1941  
 ORME ST. - EL. QUENTIN TO W.L. BLUFF  
 30' CONC WITH INTEGRAL CURB

Drawing Plan  
 1941  
 ORME ST.  
 EL. QUENTIN  
 W.L. BLUFF

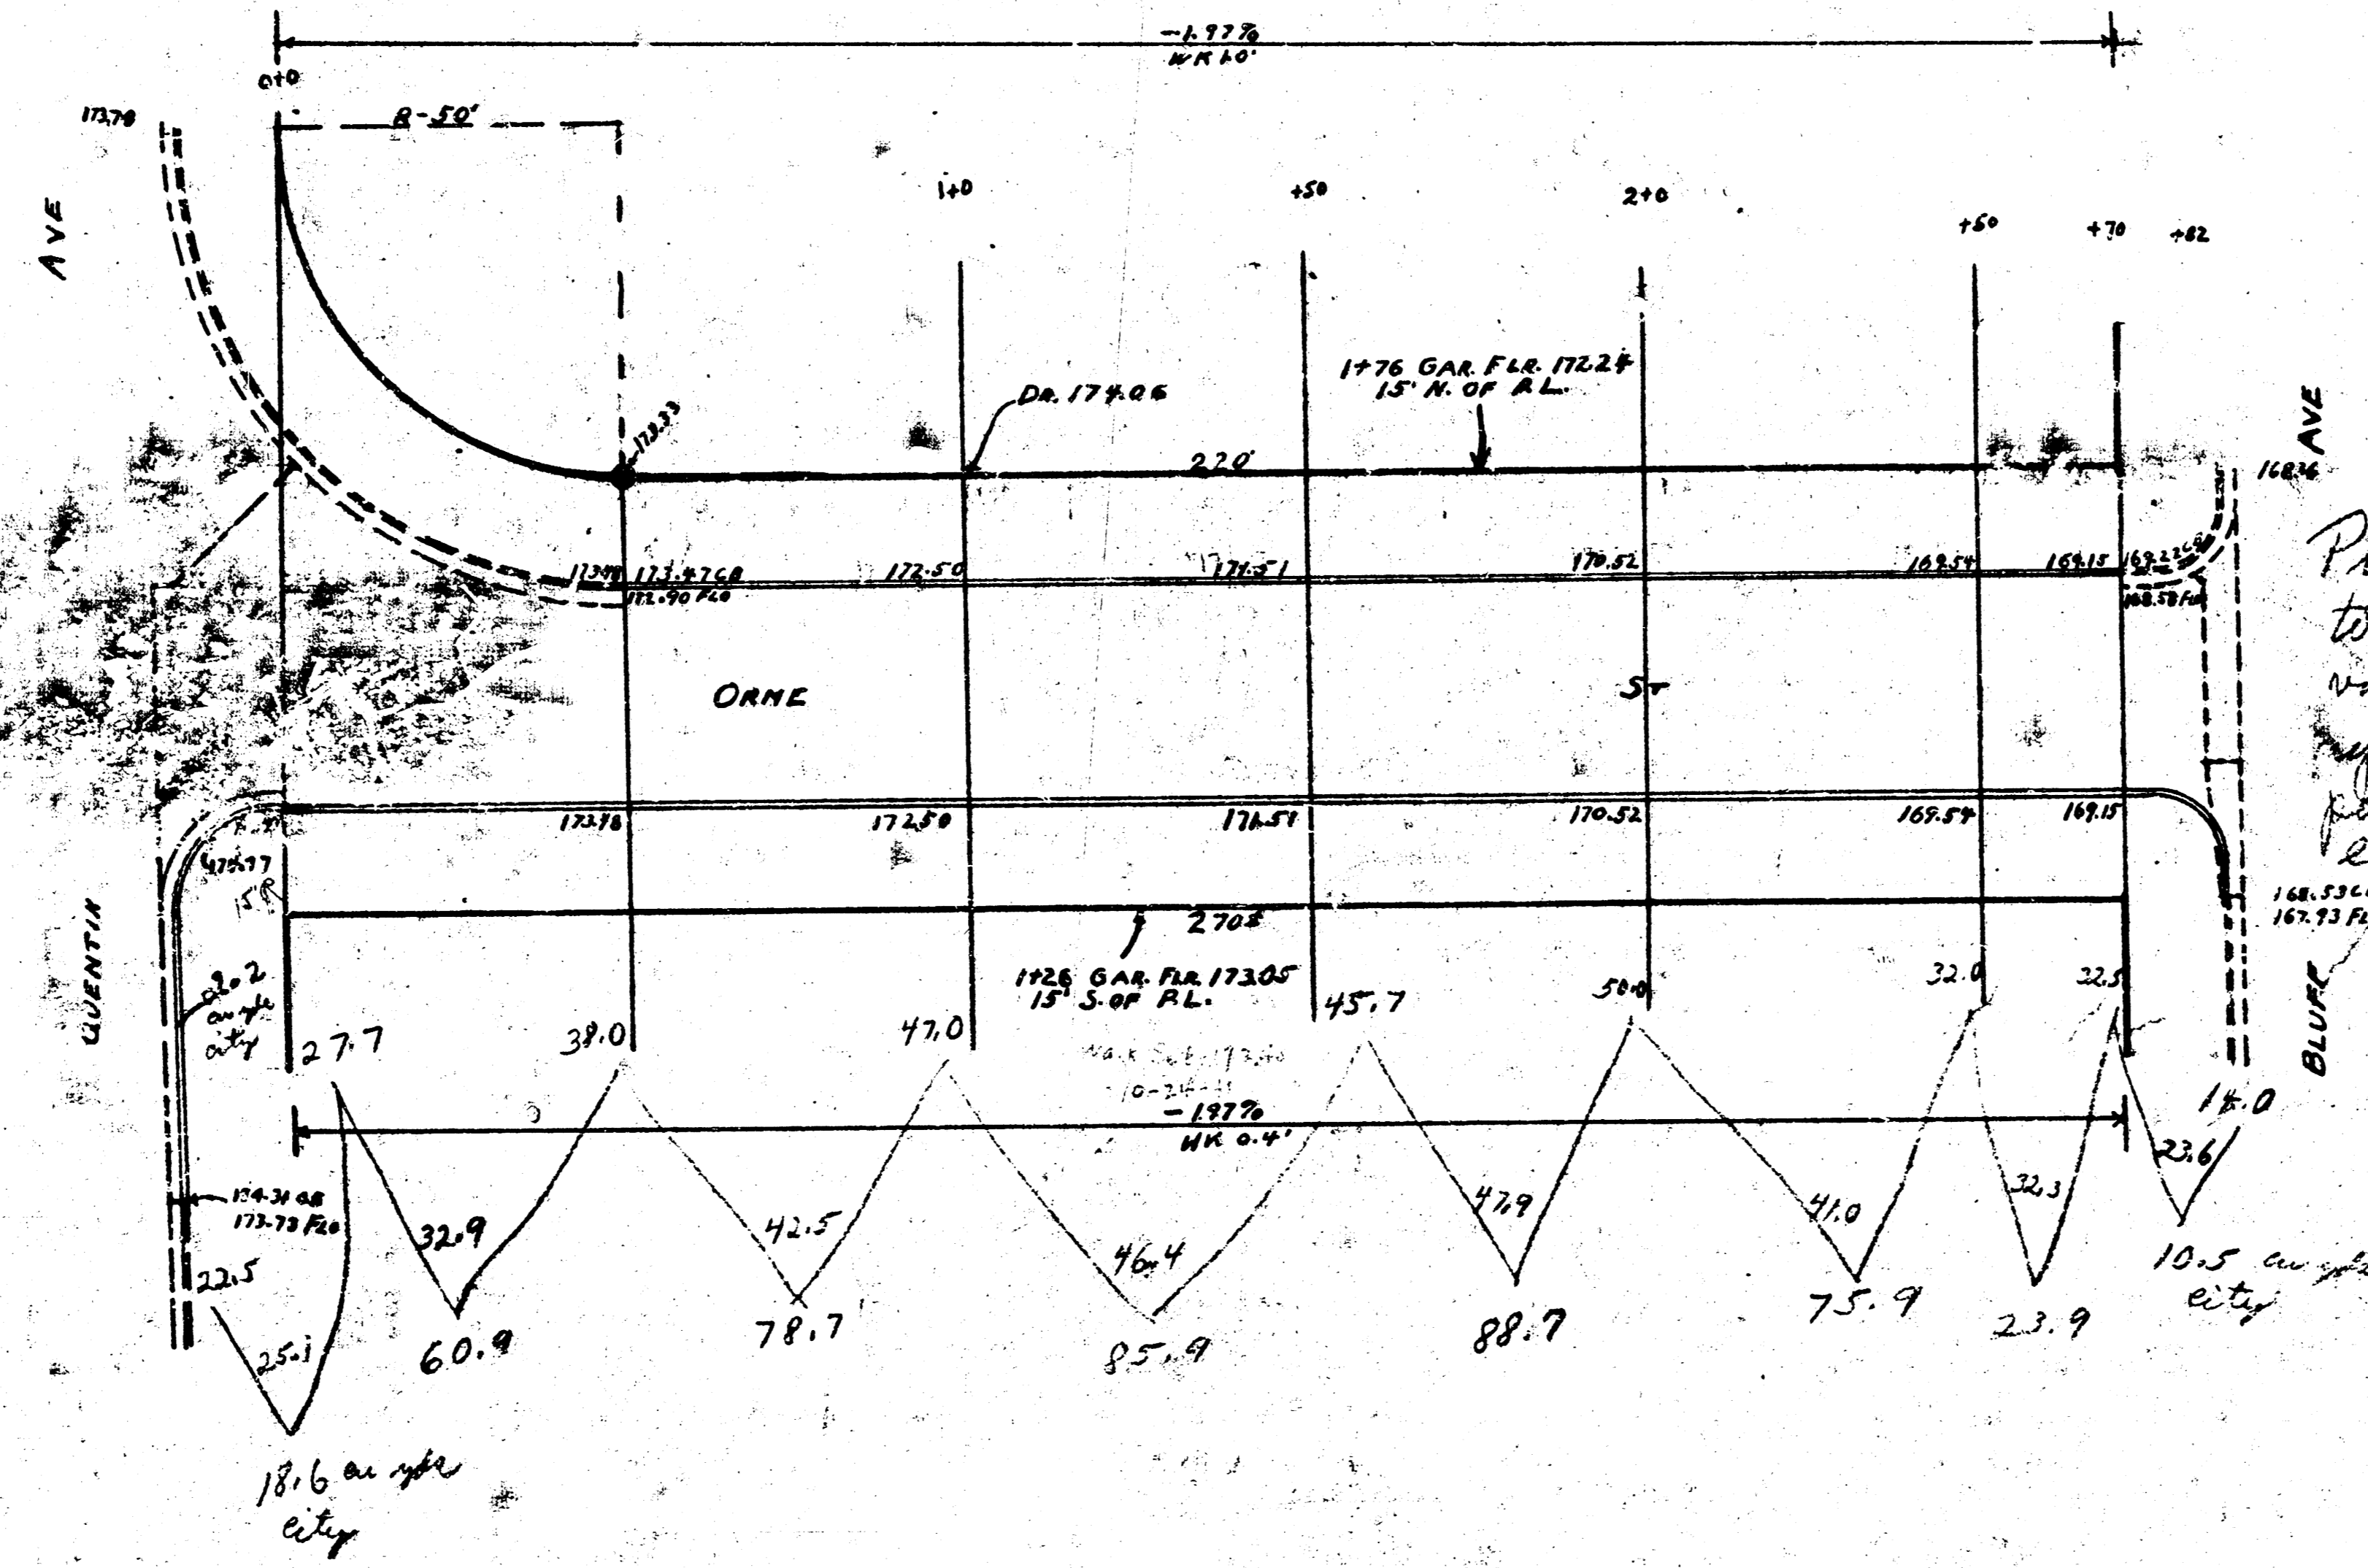
Probably advisable  
 to remove existing  
 valley gutter and  
 replace with 6"  
 pavement unless in  
 excellent condition  
 P.L.S.
